FROM: Technical Support Development

SUBJECT: **J-48837 DD15 Injector O-Ring Installer Replacement**

Figure 1. J-48837 – Injector O-ring Installer

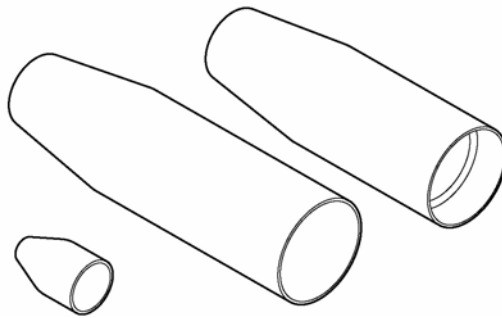
Service locations that ordered DD15 tools on the website received tool J-48837 in the DD15 support tool kit (see Figure 1). Tool J-48837-2 in this kit has been replaced by J-48837-2A. The injector diameter changed causing this tool to have an inner diameter that was too small, requiring a new tool to be made. When you receive the new tool, please remove J-48837-2 and discard it. Replace the old tool with J-48837-2A. The replacement tool will come with updated decals for the storage case and detailed instructions. Tool J-48837-2A will be sent to you at no charge from SPX.
